**Panel Report Addendum**

# Whittlesea Planning Scheme Amendment C241wsea Shenstone Park Precinct Structure Plan

**9 March 2021**

**Figure 4 Phillips Quarry – proposed work authority boundaries and extraction limits under proposed WA 6852**

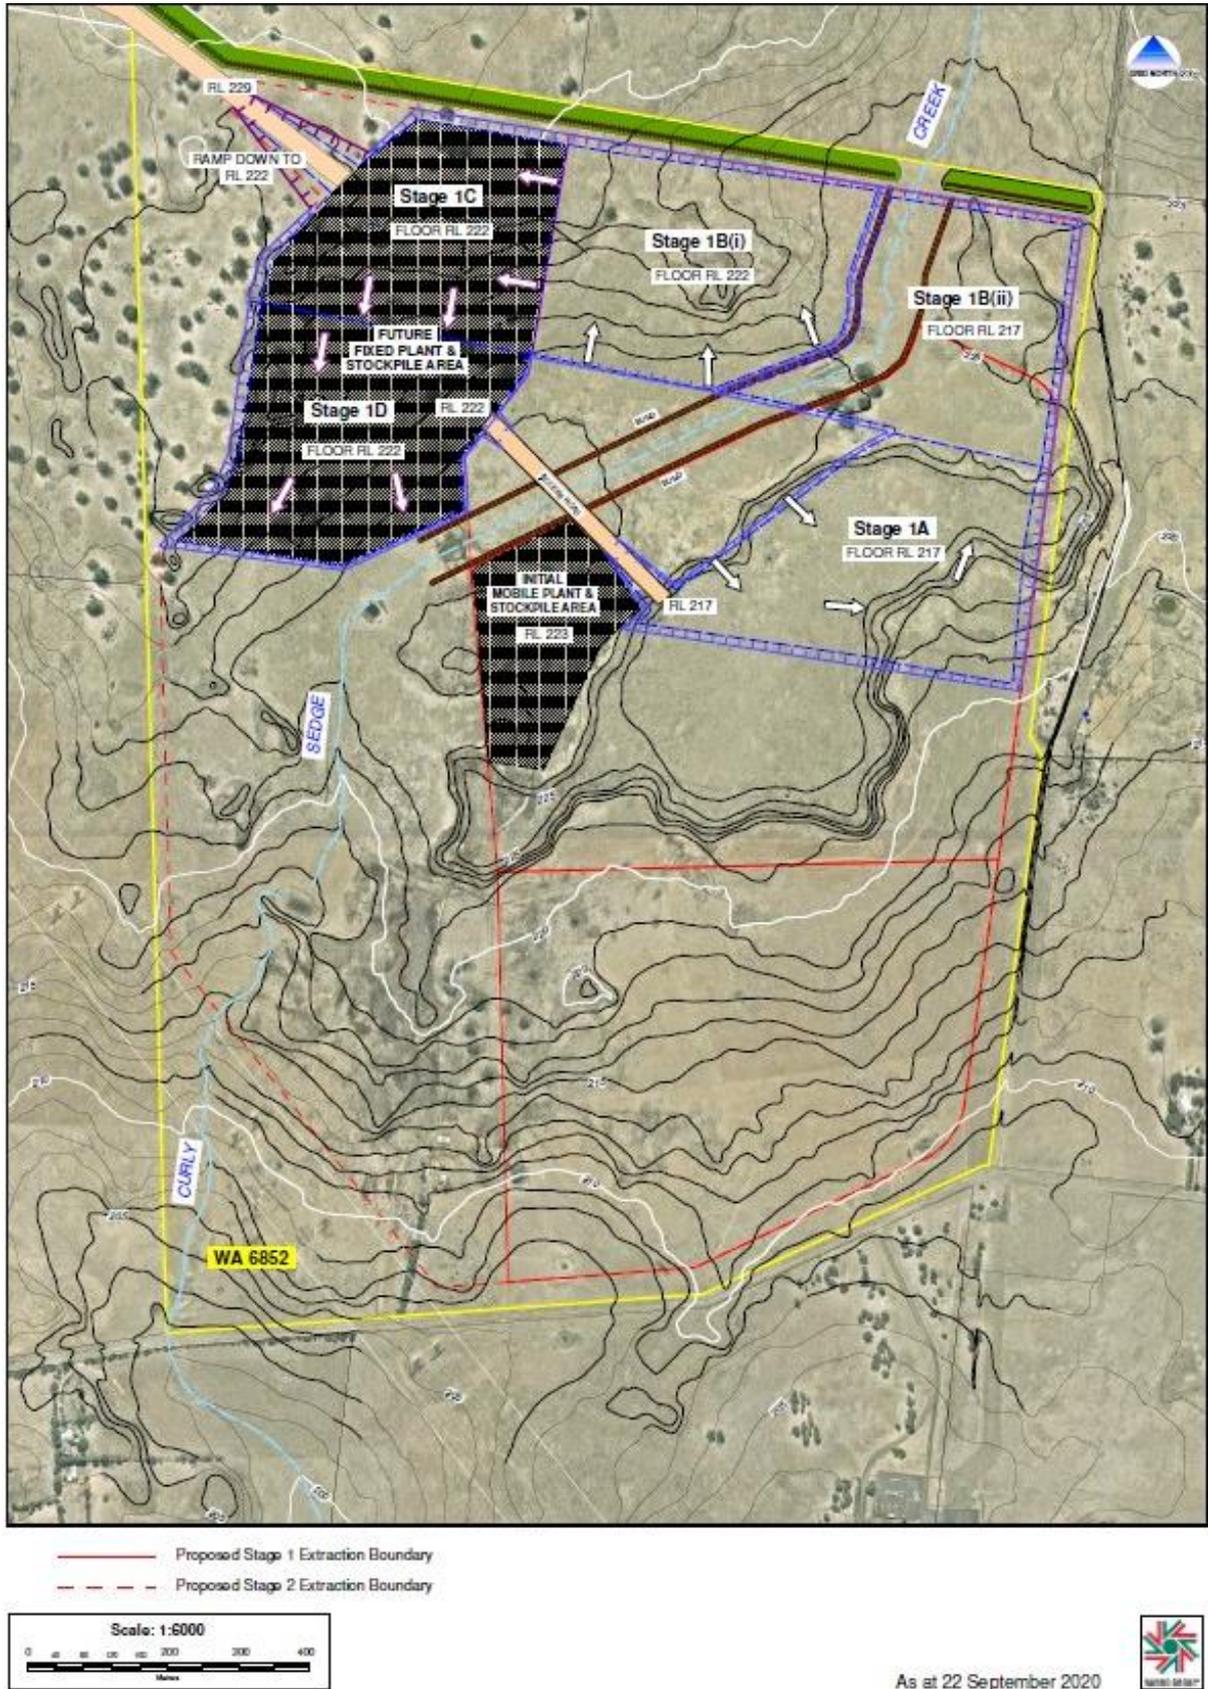
Barro submitted that the Phillips Quarry Sensitive Use Buffer should be 500 metres measured from the proposed extraction limits for the WA 6852 area (which propose internal setbacks of 45 metres from the northern boundary and 20 metres from the eastern boundary, as shown on Figure 4).

- b) show a Phillips Quarry Sensitive Use Buffer of 500 metres drawn from the proposed Extraction Limits of WA 6852 as shown on Figure 4 in this report [Chapter 5.4]

Figure 5 Exhibited Future Urban Structure

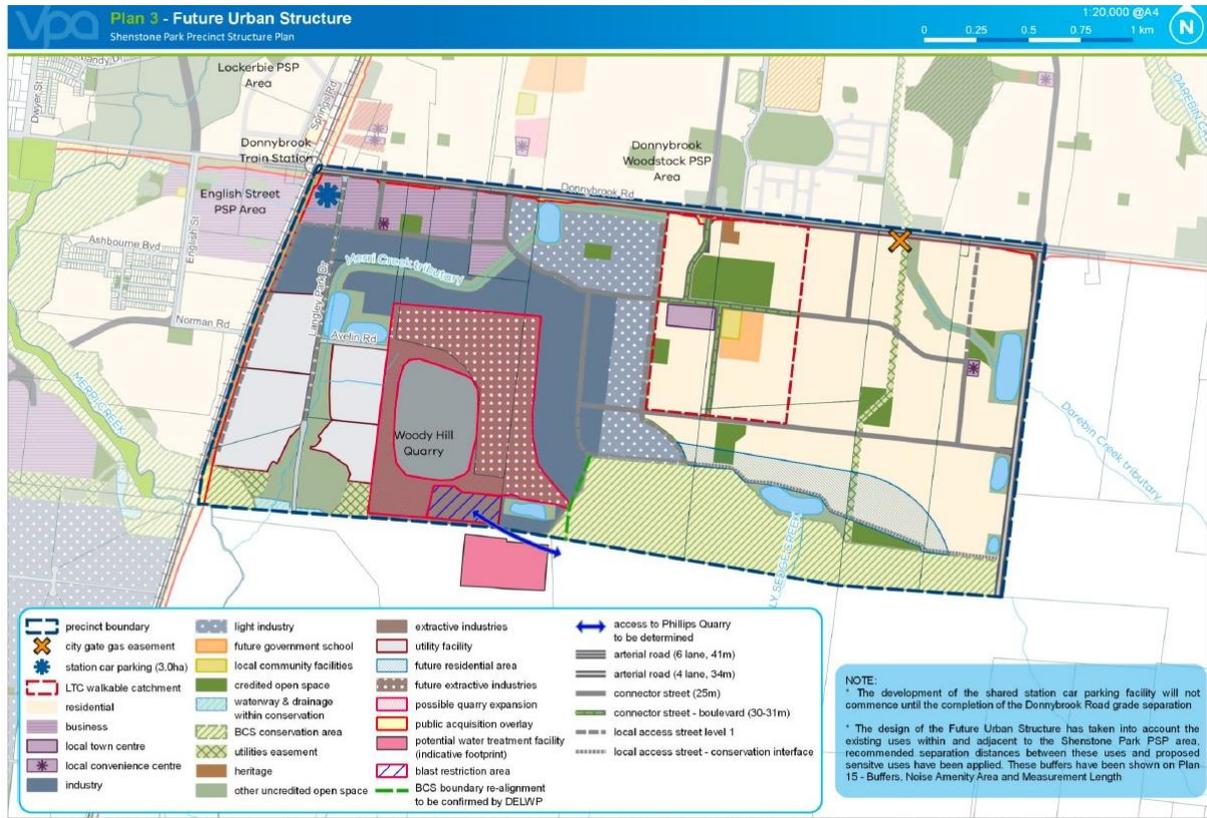
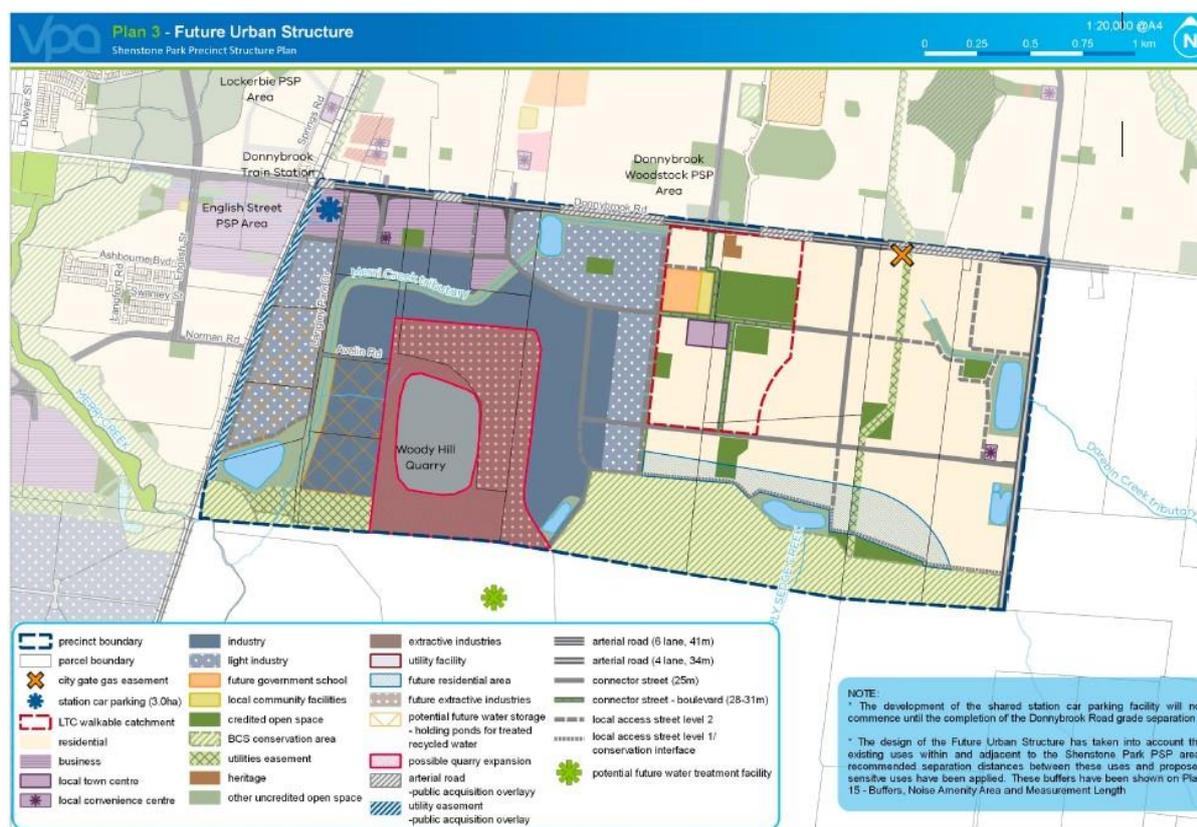
The FUS is shown in Plan 3 of the PSP. The exhibited FUS is extracted in Figure 5, and the updated FUS tabled by the VPA prior to the Hearing (the Part A version, Document 25) is extracted in

14. Amend Plan 3 (Future Urban Structure) **and Plan 1.0 in the Part C Urban Growth Zone Schedule 7** to:
- align the northern extent of the ‘future extractive industries’ area with the southern extent of the Woody Hill Sensitive Use Buffer as drawn in accordance with consolidated Recommendation 17(a) [Chapter 4.4]

**Figure 10** Access road and bund land

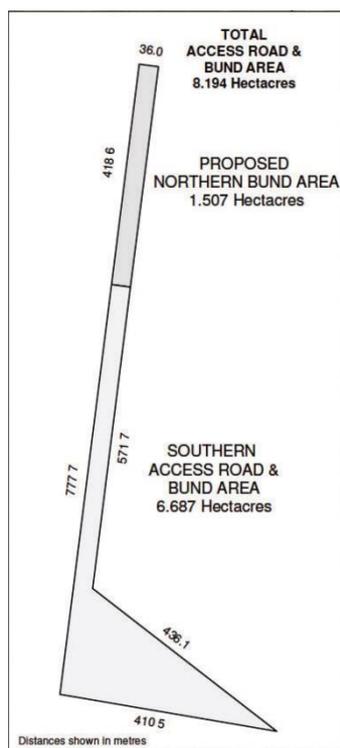
Barro and DJV (owner of the land east of Woody Hill Quarry) submitted that the eastern expansion area should not extend beyond the 36 metre wide strip of land (plus the splay at the southern end) that DJV has agreed to transfer to Barro for the purposes of the bund and access road (shown in Figure 10).

For completeness, the Panel notes that the dimensions of the splay at the southern end of the strip differ in both the exhibited and revised PSPs from that shown in Figure 10. The Panel understands that this is because DELWP was (at that stage) yet to approve the adjustment to the boundaries of the adjacent CA28. DELWP's approval has since been secured (Document 54(e)).

**Figure 11 RWTP Odour buffer recommended by Mr Pollock**

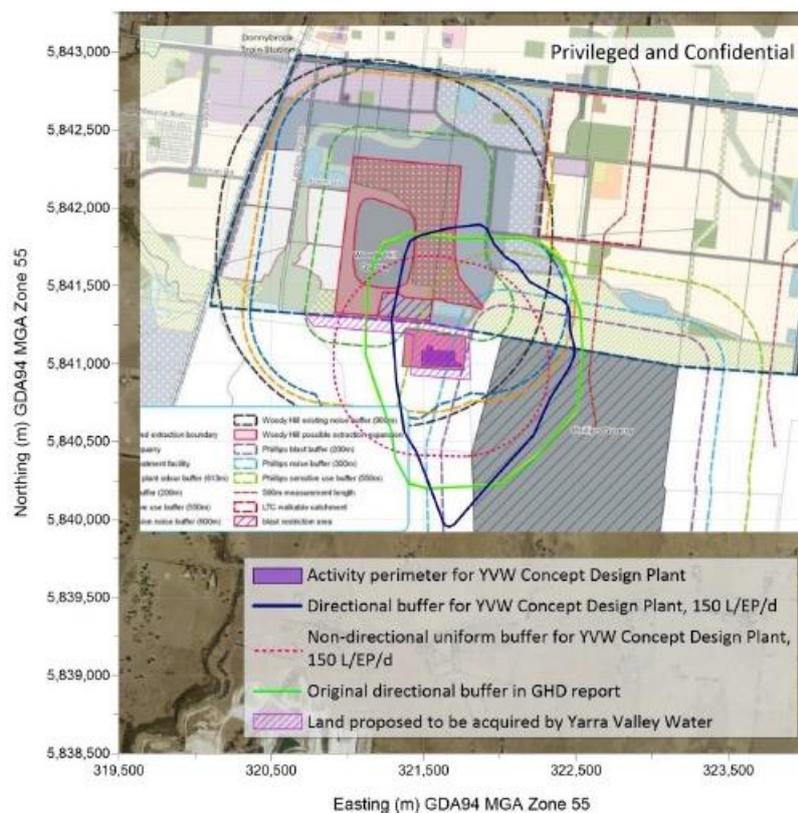
Mr Pollock's evidence was that based on the dominant wind directions which are predominantly along the north south axis, a directional buffer was appropriate, as shown in Figure 11 in blue:

Based on Mr Pollock's buffer calculations shown in Figure 11, the likely footprint of the odour buffer will be contained within the existing buffers required for the quarries, even with reduced quarry buffers recommended by the Panel. Indications are that the odour buffer would not overlay any areas designated for sensitive uses.

**Figure 16** Alternative road alignments on 910 Donnybrook Road (exhibited PSP on left - alternative on right)

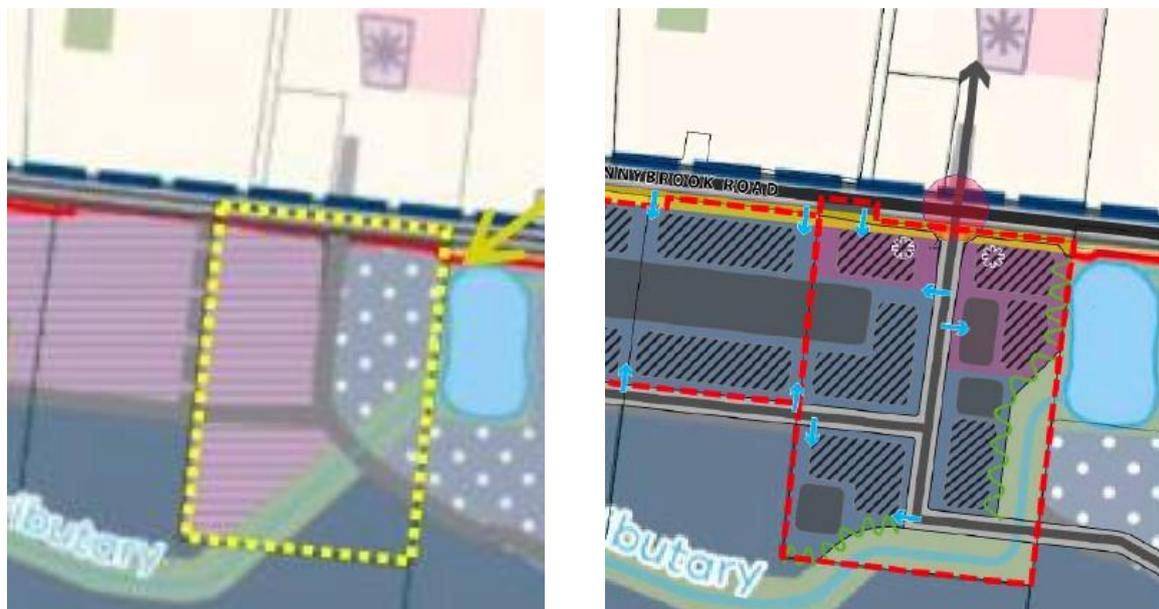
- the connector street have a more rectilinear alignment to allow for more regular lots either side, and a more efficient use of the land
- the east west section of the connector street be aligned further south on the land, adjacent to the realigned Merri Creek Tributary.

The two alternatives are shown in Figure 16.

- a) show the alternative road alignment on 910 Donnybrook Road, Donnybrook proposed by 910 Donnybrook Road Pty Ltd and Retzos as shown in Figure 16, save that the east-west connector road and the Merri Creek Tributary should be located outside the Woody Hill Blast Buffer.**
